[Crandon Mine Project comments]. Volume 4 1984-1986

COMMENTS ON PRICKETT'S MINE INFLOW MODEL
AS DOCUMENTED IN "GROUND WATER INFLOW MODEL
FOR THE PROPOSED CRANDON MINE"

Responses to DNR comments on the Revised EIR, DNR Letter Dated December 28, 1984

FIGURE 1.3-19

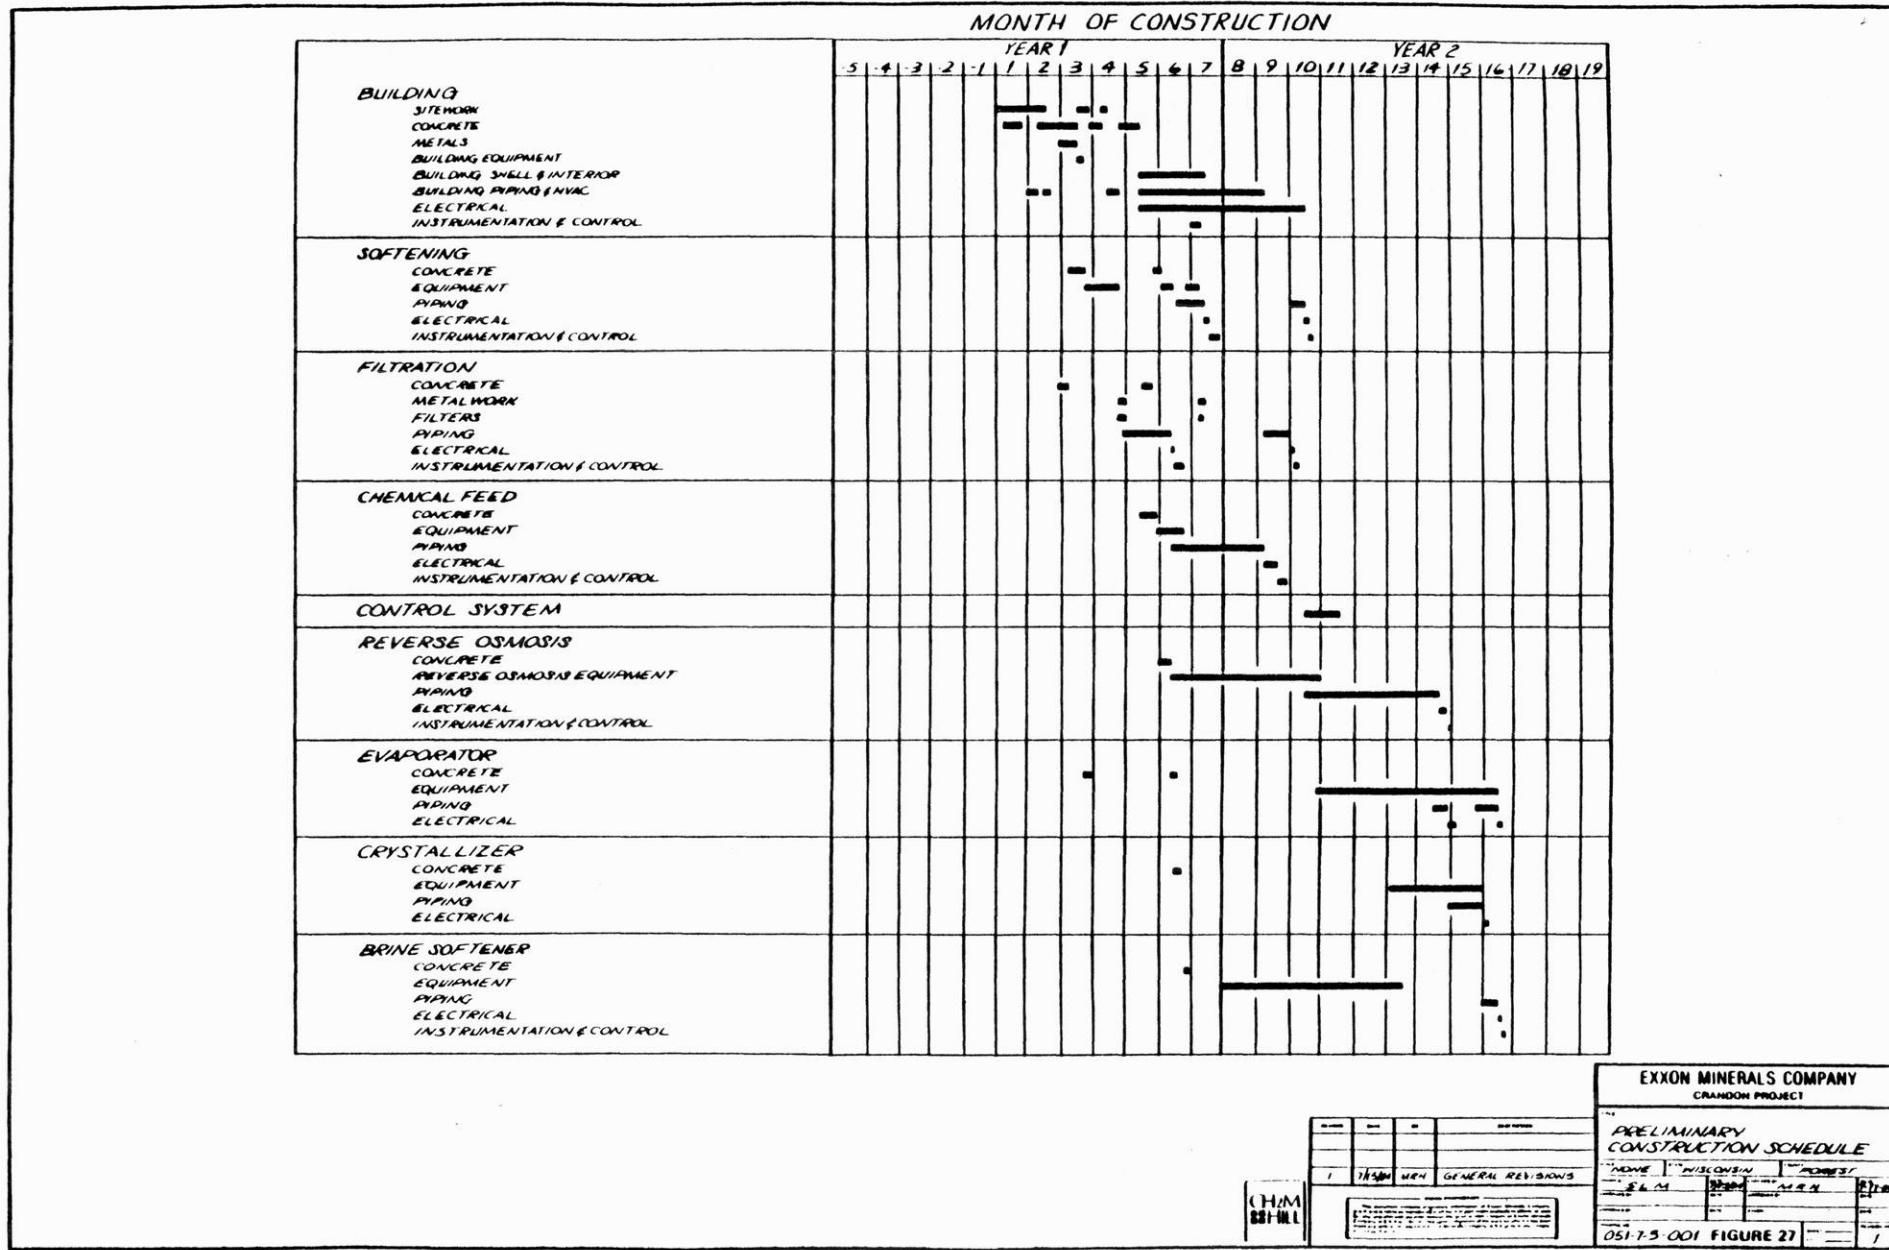
Figures 1.1-15 and 1.3-19 show the construction schedule for the entire project, including that for the wastewater treatment plant (WTP) and the reclaim ponds. These schedules differ significantly from that presented for the WTP in the Preliminary Engineering Report dated October 19, 1984. Which is the correct schedule? Is there an updated EIR project schedule available?

It is presumed that the above referenced figure is 1.1-5 as there is no Figure 1.1-15.

Figures 1.1-5 and 1.3-19 from the revised EIR showing the Project construction schedules have been updated and are consistent with the wastewater treatment plant (WTP) Preliminary Engineering Report dated October 19, 1984. The updated Project schedules were contained in the February 1985 revision to Chapter 1 of the EIR which was previously submitted to the DNR. Copies of these figures are attached.

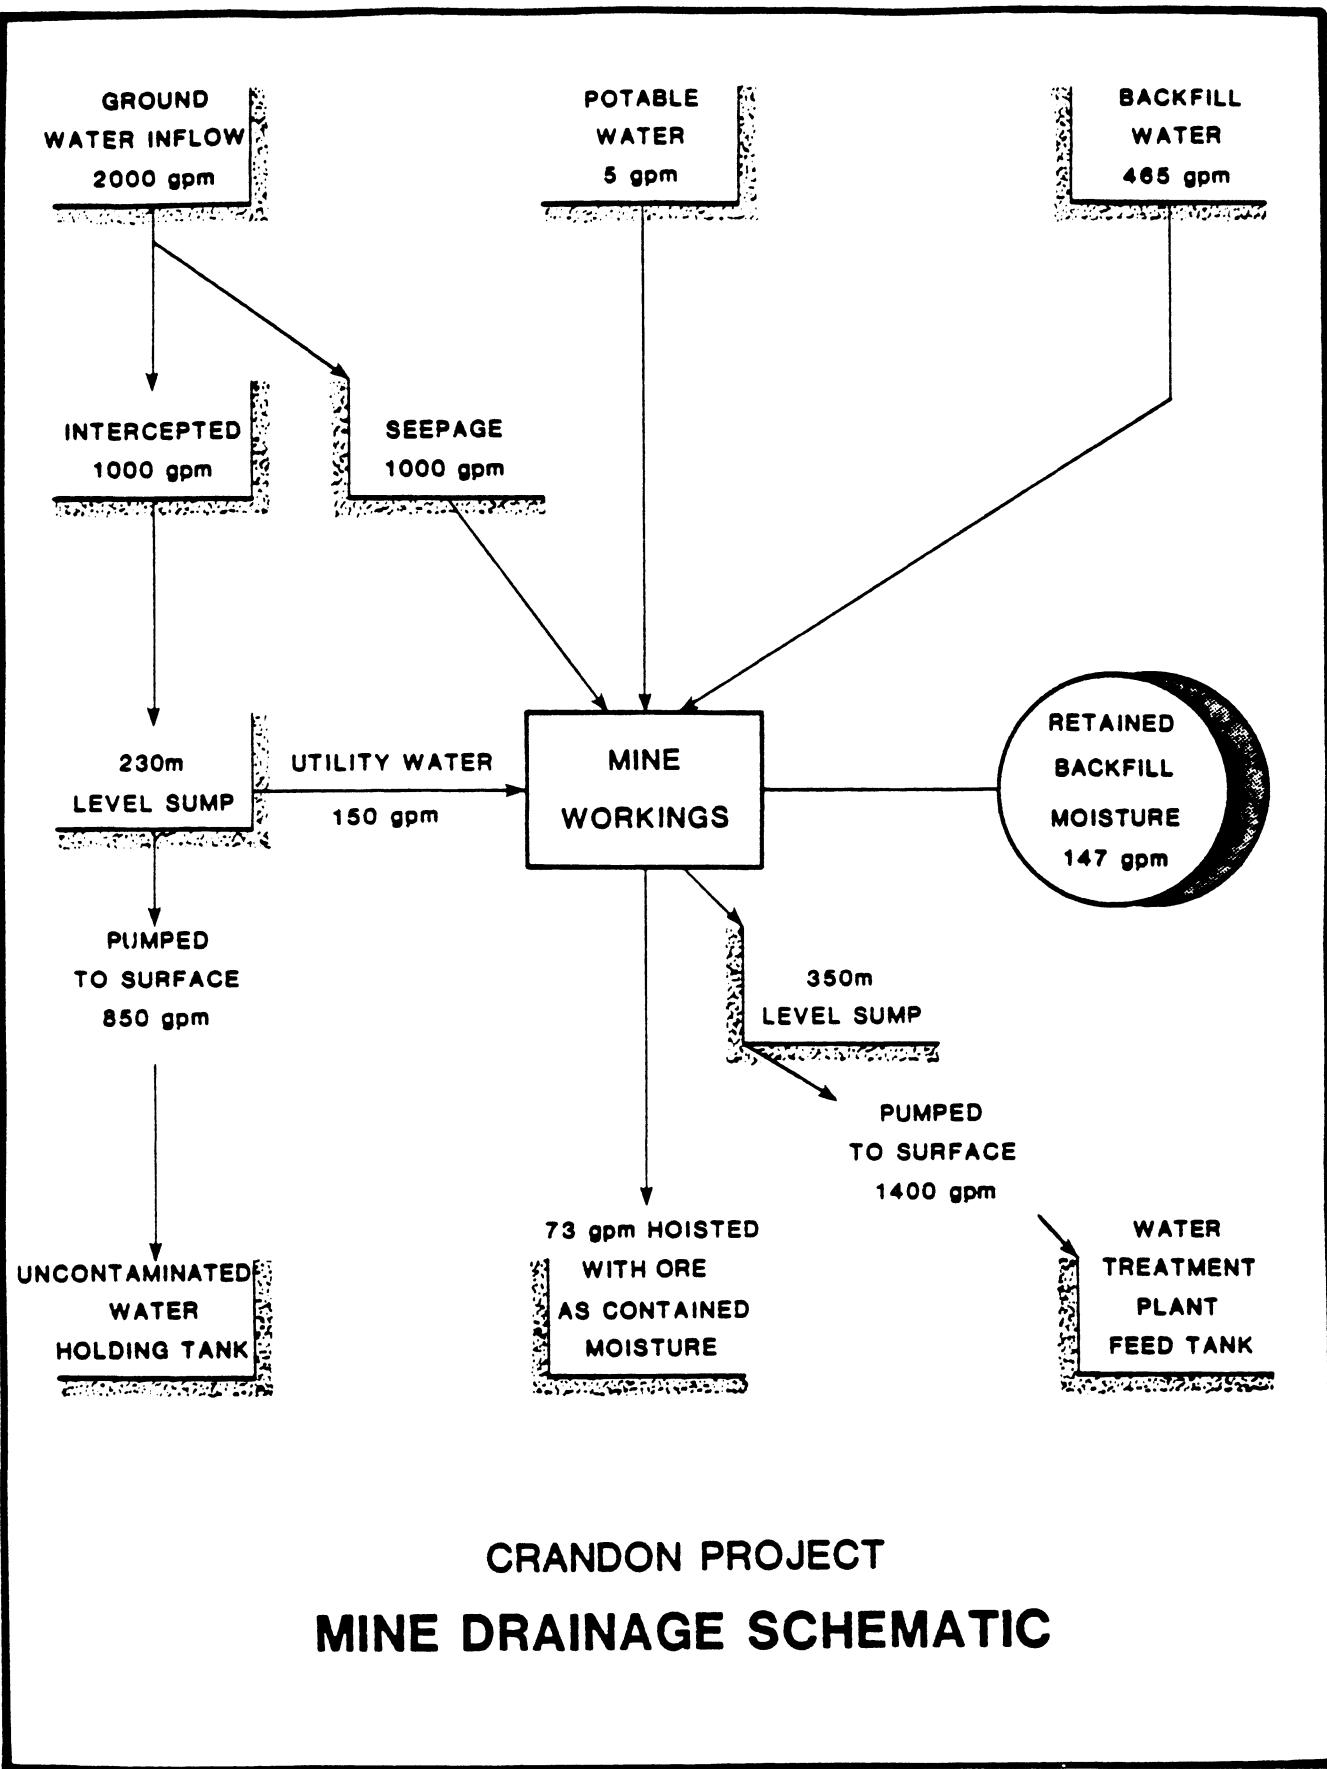
The 2,000 gallons per minute cited for site area impact modelling and system design is inconsistent with the revised Appendix 4.1A. A maximum of 1,600 gallons per minute was used for impact modelling and it is unclear what figure was used for mine water handling system design.

The mine pumping and drainage design basis, depicted on the attached Figure 1, provides for a steady state ground water inflow of 2,000 gallons per minute or 25 percent more than the steady state inflow range of 934 to 1,592 gallons per minute predicted by the mine inflow computer modelling (D'Appolonia, 1984). Mine pumping systems have been designed for a total capacity of 2,600 gallons per minute to account for other mine water flows such as backfill water drainage, potable water, utility water, bedrock storage depletion and minor downtime on the pumps. Each operating pump will be backed up by an installed spare. Dual full capacity pump discharge columns to the surface will be provided.

(FIGURE 1 FOR THE RESPONSE TO COMMENT NO. 7)

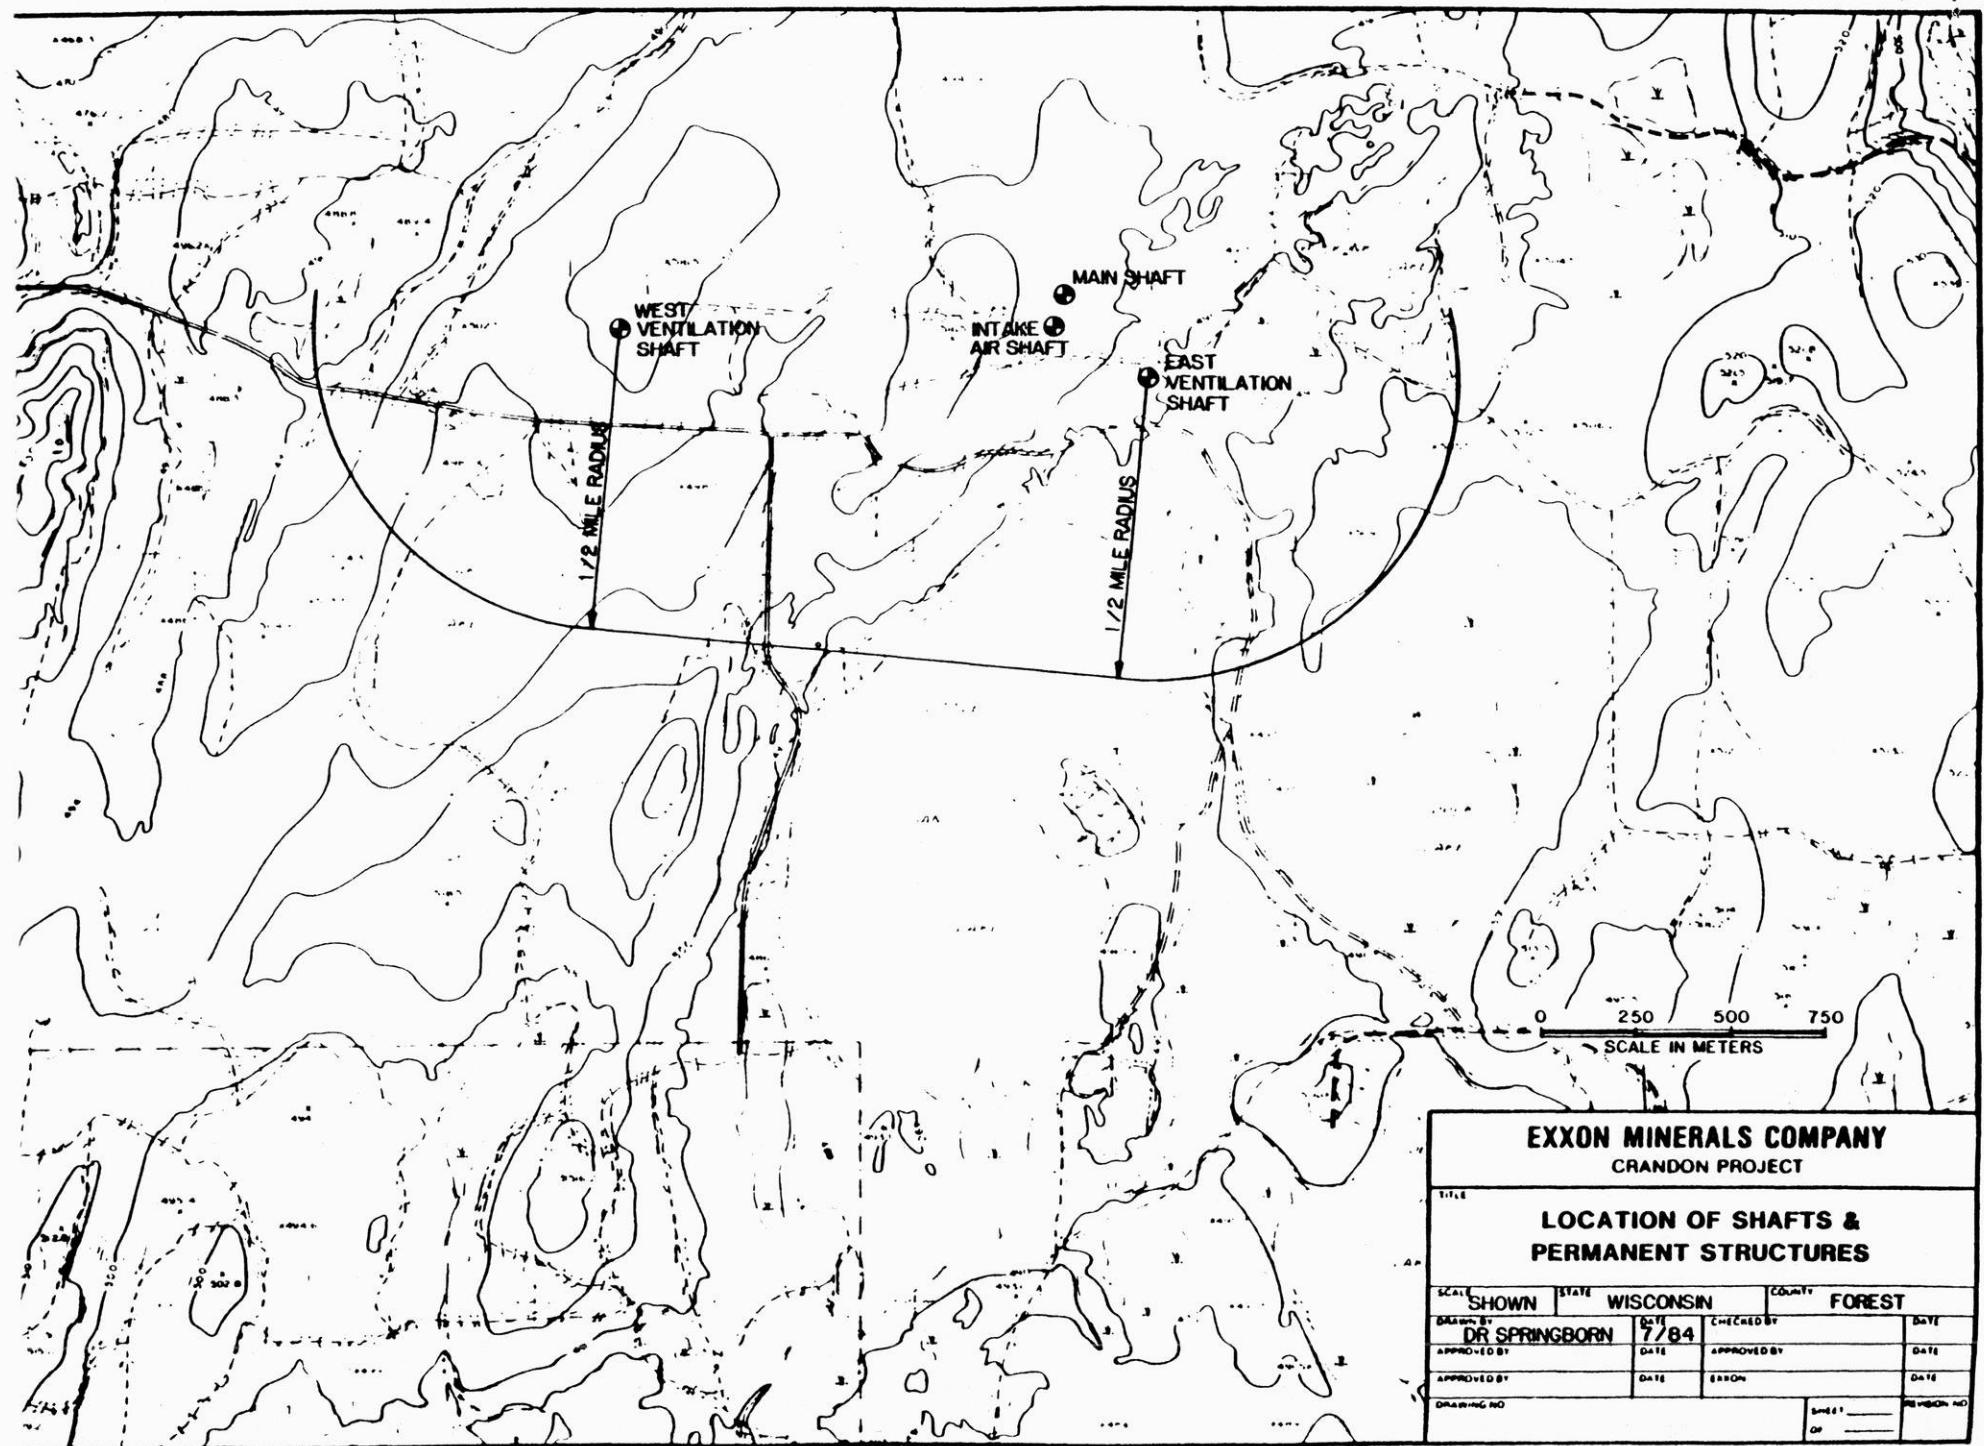
Has a plan been developed for monitoring surface level vibrations when blasting begins? If so, this should be submitted. Otherwise, a blast vibration monitoring plan should be developed.

A description of the proposed blast monitoring plan was previously provided in the response to DNR comment No. 45 on the Mining Permit Application (letter from B. Hansen, EMC, to G. Reinke, DNR, dated July 31, 1984). Also, the blast monitoring plan was described in the response to comment No. S5 on the noise reports (letter from B. Hansen, EMC, to R. Ramharter, DNR, dated October 31, 1984). The proposed blast monitoring plan, as presented in EMC's response to comment No. 45 on the Mining Permit Application, is repeated below.

Site blast monitoring will be limited to verification of design parameters during initial construction and mine operation events. Modern blasting agents and delayed initiation techniques will be employed as required by site conditions to control blast vibration and overpressure. All blasts will be designed to preclude damaging seismic, air blast, or noise effects immediately adjacent to all four mine openings to the surface (see attached Figure 1). Such protection of site personnel and physical facilities implies that off-site blast effects will be well below annoyance levels, if not totally imperceptible.
